# Response to London Borough of Camden's additional Sustainability and Energy comments

13 Blackburn Road

Project No: 55186

Date: 23/02/2023

Figure 1 - Potential PV allocation on the residential blocks

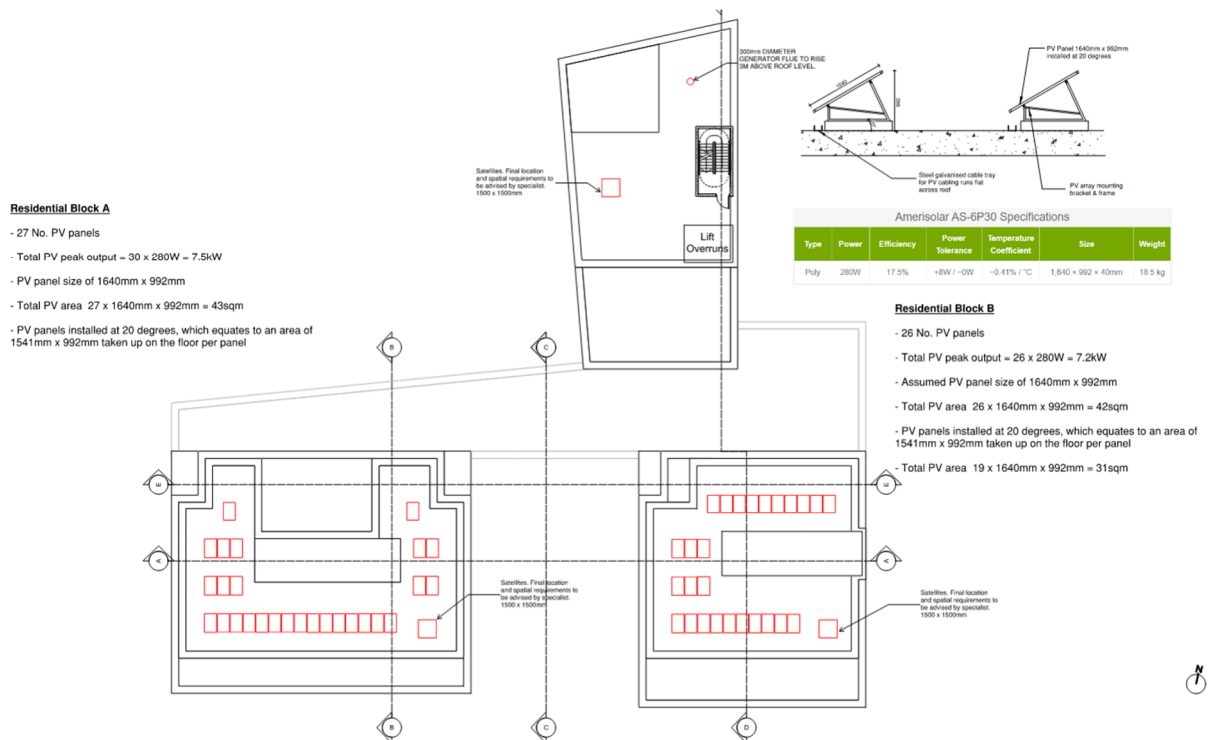
**Issue 1:** Consider viability of installing Solar PV integrated with the blue/green roof.

A feasibility study has been carried out to identify the available roof areas to incorporate photovoltaic panels. This study suggests that the roof of the residential blocks has the potential to accommodate up to a total number of 53 PV panels, providing an electrical output of 14.7 kWp. The potential allocation of the PV panels is presented in the figure below.
